Hereford Southern Link Road

Planning Application and Design Review

Project Number 60715938

February 2024

Figure 1 - Current Route Plan and Longitudinal Section Drawing

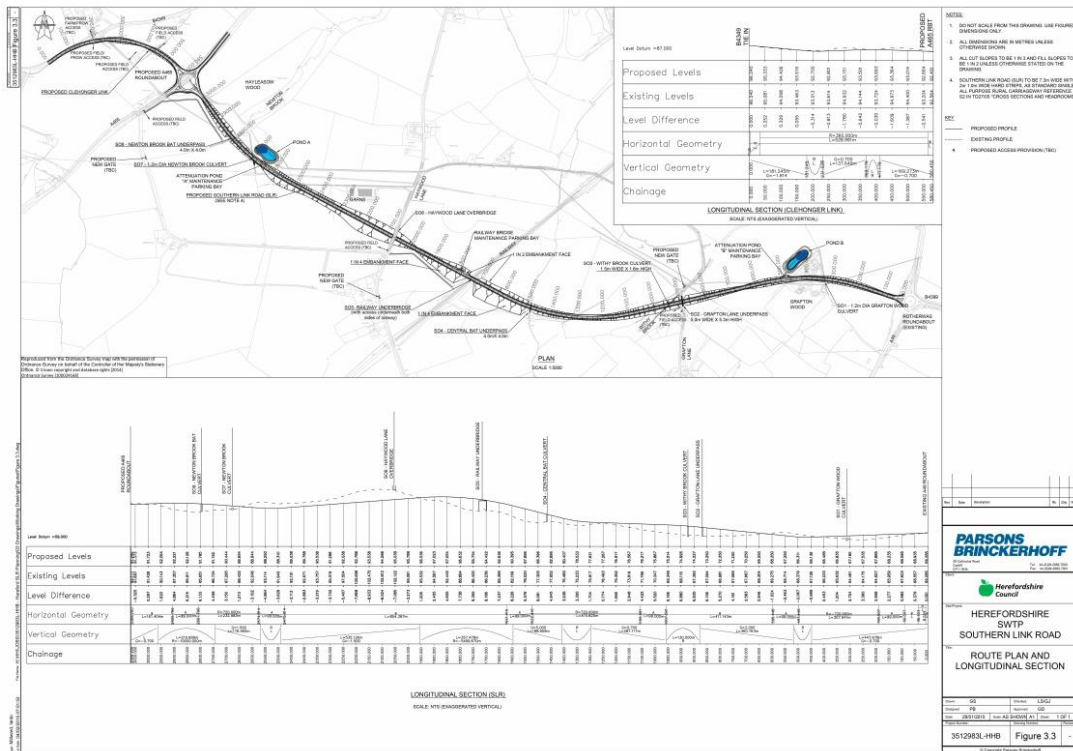
The maximum gradient for the proposed SLR, of 5%, is below the desirable maximum of 6% for an All-purpose single carriageway as outlined in CD109 Table 5.1 and therefore acceptable. On the Clehonger Link, the longitudinal gradients along the tangents range between minimum -1.84% and maximum 0.7%. In the locations of the horizontal alignment where superelevation is required, the longitudinal gradient is greater than + or - 0.5% which meets the recommendations of CD109 clause 4.8.3 (this is not a requirement). There are no issues with the maximum gradient of 0.7% if the highway drainage gullies have been spaced appropriately.

With regards to the SLR, the vertical geometry uses a combination of 3 crest curves and 3 sag curves. The three crest curves have K values of 100, 55 and 100 respectively whilst the 3 sag curves have K values of 26. The desirable minimum crest K value for a design speed of 100kph is given as 100 in CD109 Table 2.10 whilst a value of 55 is one step below the desirable minimum crest K value. Likewise, the desirable minimum sag K value for a design speed of 100kph is given as 26. In summary, the sag and crest curves meet the desirable minimum values, except for one of the crest curves which is one step below the desirable minimum. As for the Clehonger Link, it uses a single crest and sag curve with K values of 36 and 24 respectively. The crest curve is above the desirable minimum requirements from CD109 Table 2.10 of 30 while the sag curve is also above the corresponding desirable minimum requirement of 20.

In summary for this section, there is a one-step relaxation in vertical curvature on the SLR for the crest curve with K value 55 located between chainages 1600.000 and 1950.000.

Figure 2 - Illustrative Cross-Section of the proposed Southern Link Road

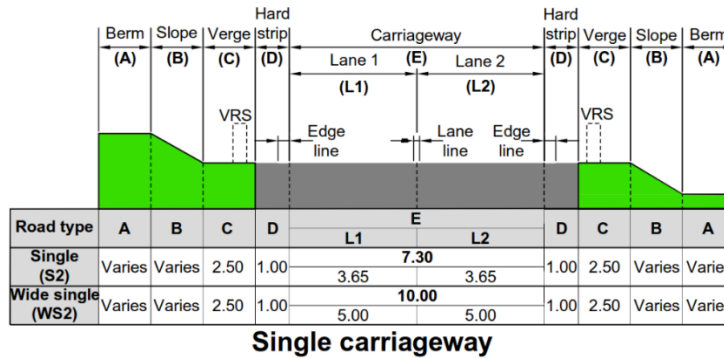
The Planning Statement states that the SLR has been designed as a standard two lane single, all-purpose rural carriageway in accordance with Figure 4-3a of TD27/05 'Cross-sections and Headrooms'. This standard has been superseded by CD127 'Cross-sections and Headrooms', however a review of the same cross-section

(Figure 2.1.1N1e) in the updated standard shows no change in the dimensions of the cross-section components of the SLR design. The planning statement noted that the Clehonger Link also used the same cross-section except for the omission of the hard strips giving an overall hard surfacing width of 7.3m.

Measurements were taken along both the SLR and the Clehonger Link and the widths for the lanes and hard strips areas were found to match the dimensions from Figure 2.1.1N1e (shown in figure 2 above). The verge width is 2.5m along most of the scheme route however it has been widened where other design features like drainage pipes have had to be accommodated. These changes are deemed acceptable.

Figure 3 - Proposed markings at the traffic island

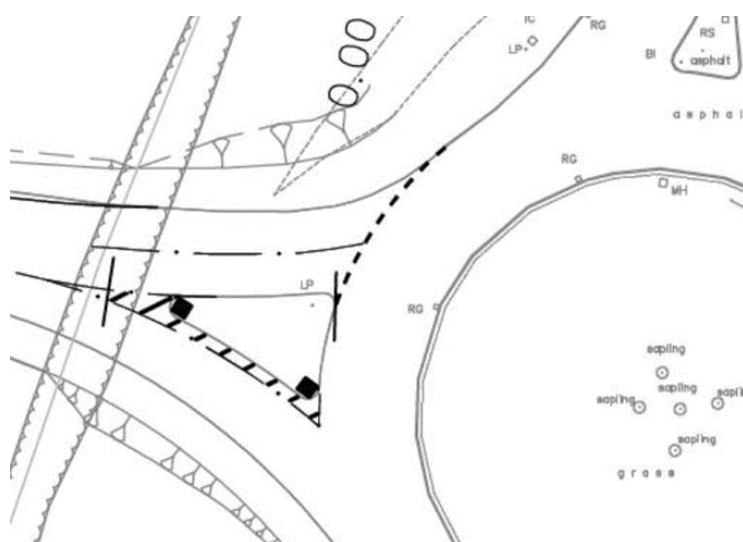
With regards to the existing roundabout at the A49 / B4399 junction, where a new western arm is proposed, the geometric design is acceptable in the most part. However, there is a safety concern regarding the traffic island on the western arm where the kerb line isn't tangential with the central island. A review of the road marking plan shows that hatched markings have not been provided on the side of the island for eastbound traffic approaching the roundabout, which could have been used to adjust vehicle paths, so the edge of the markings were tangential with the central island. The current arrangement increases the likelihood of vehicle paths overlapping. The entry width on the western arm is currently circa 7.5m so there is potential scope to adjust the lane width to accommodate the hatched markings. Further work is suggested to remove this safety concern. There are no issues with the visibility requirements of the western arm of this roundabout for the most part, however the location of the highway boundary fence may impact the approach visibility. Without the 3D digital files in AutoCAD format it is difficult to ascertain the exact location of the fence and whether it intrudes into the visibility splay. A detailed review of all the roundabout arms has not been undertaken at this point in time due to the lack of detailed information.

Figure 5 – Existing design cross section

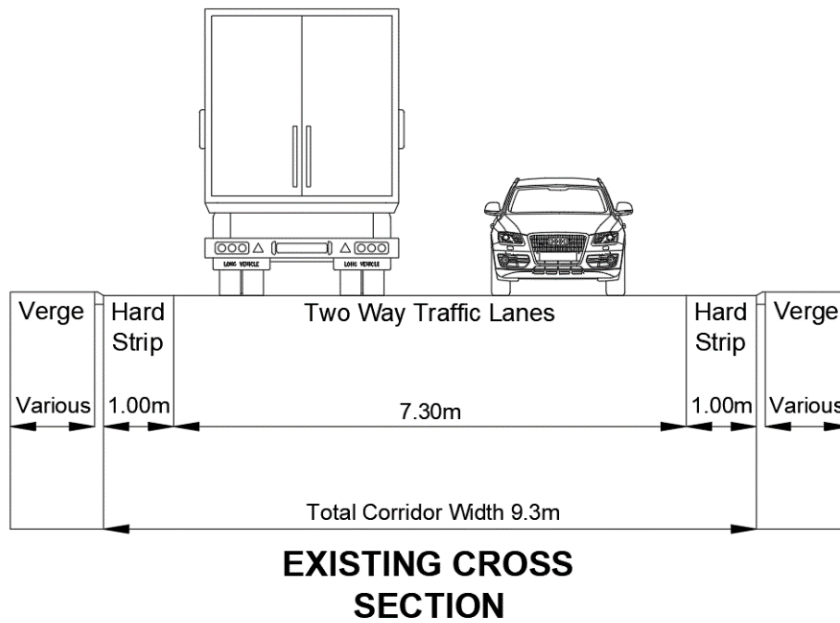
The existing corridor design for the Southern Link Road consists of two 3.65m wide carriageway lanes with a 1m hard strip at either edge before joining the verge which consists of various widths across the scheme, this equates to a total hard standing corridor width of 9.3m. There are six proposed bridges/culverts across the SLR including over the railway which along with the restricted red line boundary provide major constraints for the consideration of active travel measures.

Figure 6 - LTN 1/20 Desirable minimum cross section

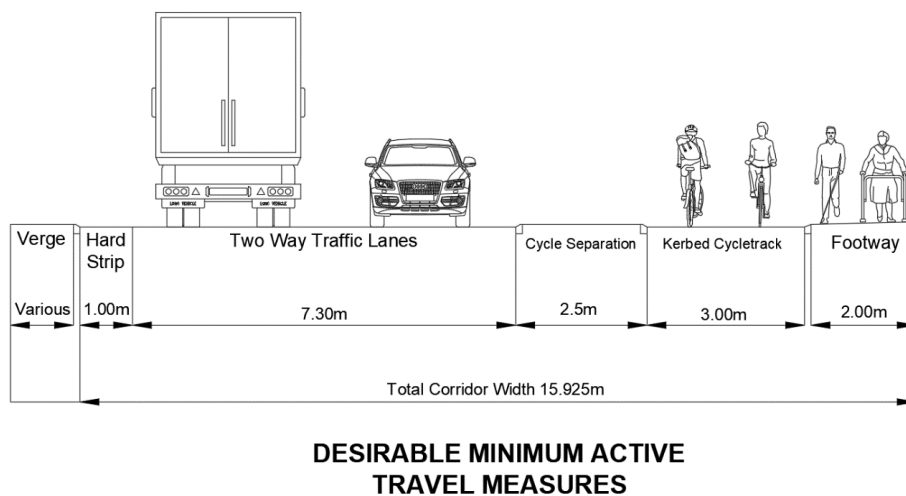
LTN 1/20 refers to desirable minimum widths for cycle tracks and traffic separation. In the SLR case, the desirable minimum protected space for the 2-way cycle track is 3m. While the desirable minimum separation between carriageway and cycle track along a 60mph road is 2.5m. Also included is a 2m desirable minimum footway. Using these design parameters, the new total corridor width becomes 15.8m not including the verge to the side without the active travel measures. The assumption for the active travel measures is to replace the existing corridor with the active travel corridor about the centre line of the existing design with the active travel measures placed on the north side of the scheme, this will alleviate the need to redesign the alignment of the existing SLR design. The proposed active travel measures considered will require an additional hard standing width of 6.5m to the north. The proposed active travel corridor is shown below. It should be noted that there may be scope to reduce the footway / cycleway width to absolute minimum with a shared facility which may be more appropriate at this rural location.

Figure 7 - National Cycle Route 46

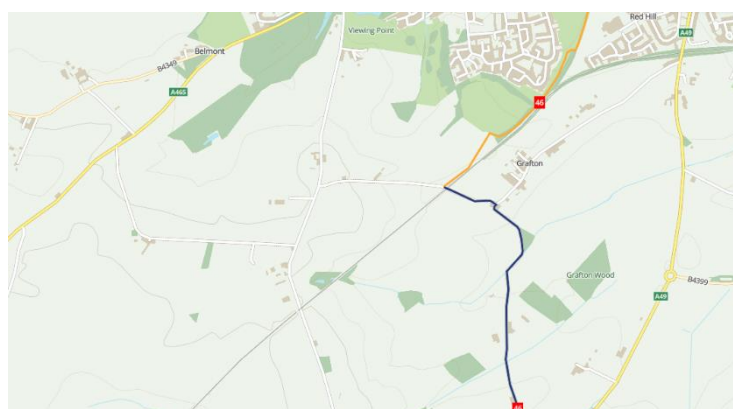
Grafton Lane is the highest demand creator for active travel on the SLR. National Cycle Route 46 runs along Grafton Lane with an off carriageway shared cycle route approximately half a mile north of its intersection with the SLR continuing into the centre of Hereford. National Cycle Route 46 runs from Bromsgrove in the West Midlands to Neath in Wales and so presents high cycle demand. The connection of this cycle route to the SLR could be an important factor in the proposal of active travel measures to support better cycle connectivity to the surrounding areas and settlements.

Clehonger is around 2 miles west of where the SLR will meet the A456 along the B4349. If active travel measures were available along the SLR then it may help to promote the use of active travel for people in Clehonger and the surrounding area to access Hereford City Centre by utilising access to National Cycle Route 46. However, as previous reports have mentioned, it may be more beneficial to provide this demand with the improvements of cycle connectivity along the A465 and the A49 as these routes provide a more direct journey into the city centre.
